**Re:** Resubmittal of Draft Final Remedial Investigation and Feasibility Study  
Warden City Water Supply Wells Nos. 4 and 5  
1900 Block W 1<sup>st</sup> Street, Warden, WA 98857  
Cleanup Site ID 1618; Facility/Site ID 2802409

**Re: March 2018 Draft Remedial Investigation and Feasibility Report  
Simplot Grower Solution, 1800 W. 1<sup>st</sup> Street, Warden, WA 98857**

Following are responses to comments received via email on March 29:

**Figure 17. Estimated Limit of EDB in Soil**  
**Simplot Grower Solutions,**  
**1800 W 1st St., Warden, WA 98857**

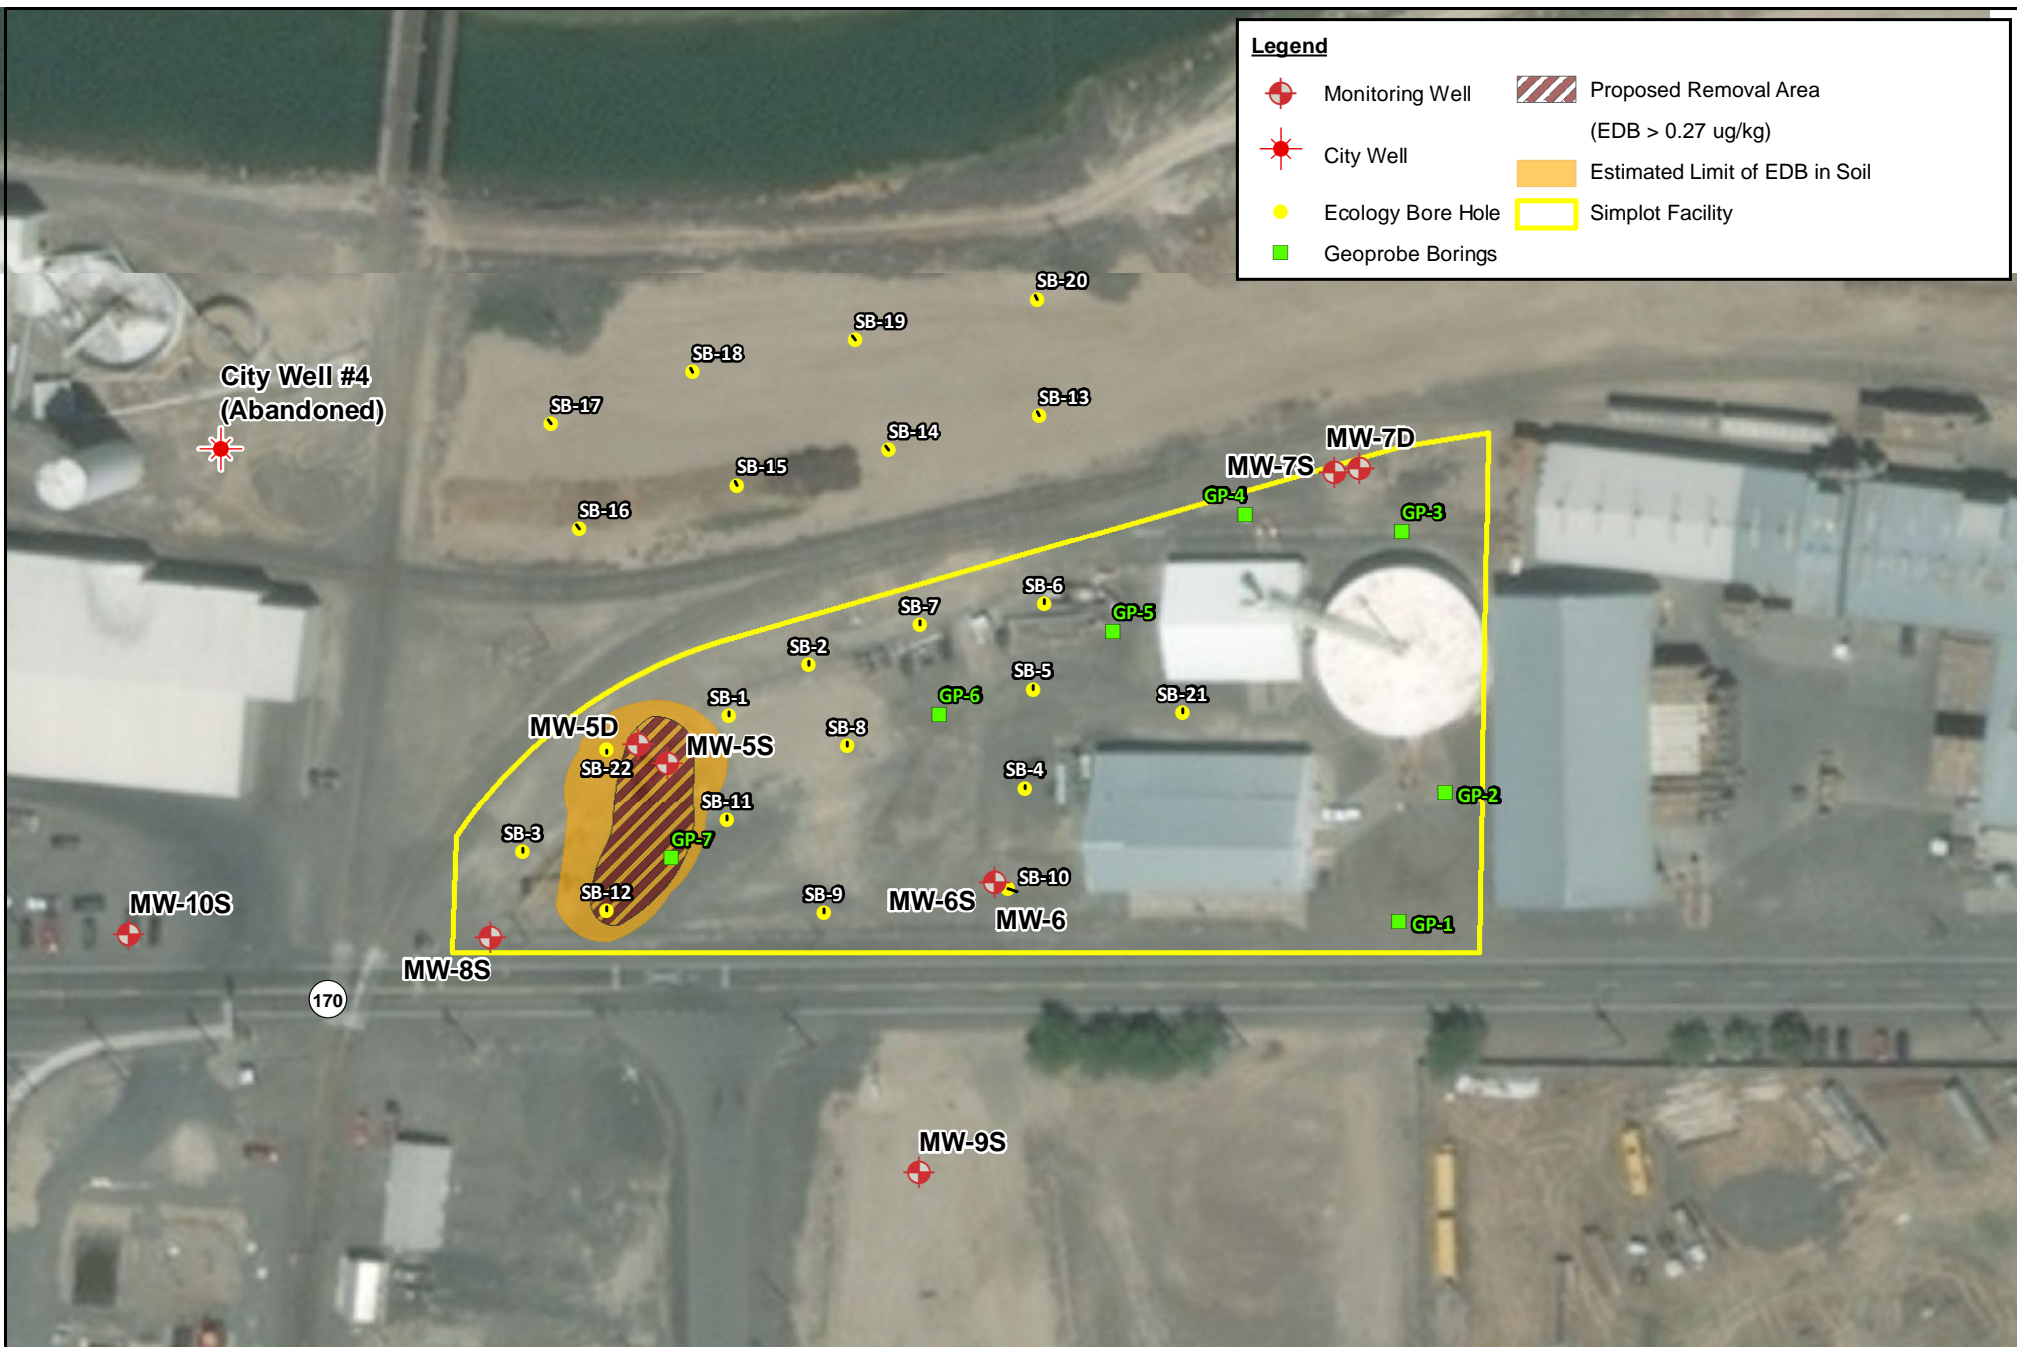
**Comment 7:** Subsection 2.2.6.3.3- Alternative 3-Institutional Controls...etc. eighth bullet: Simplot is proposing one conditional Point-of-Compliance well at the western side of the Site. Because groundwater flow fluctuate from a southerly direction in the summer to a westerly direction in the winter, Ecology suggest that three conditional Point-of-Compliance wells are installed at the west, southwest and south boundaries of the property from the area to be excavated. This is in order to capture potential off-site migration of EDB due to alternating groundwater flow directions.

**Response:** Per our conference call, the compliance wells would be 8S (existing well to the southwest of the soil EDB area), new well to the west (MW-11S) and a well to the northwest (MW-12S). Furthermore, MW-5S and MW-5D would not be replaced following excavation in the area of these two wells.

- Wells MW-5S and MW-5D would be decommissioned and wells MW-11S and MW-12S would be constructed to the west and northwest along the property boundary, respectively (see **Figure 17**). This new wells along with MW-8S would be monitored before and after excavation activities. Wells MW-5S and MW-5D would not be replaced following excavation.
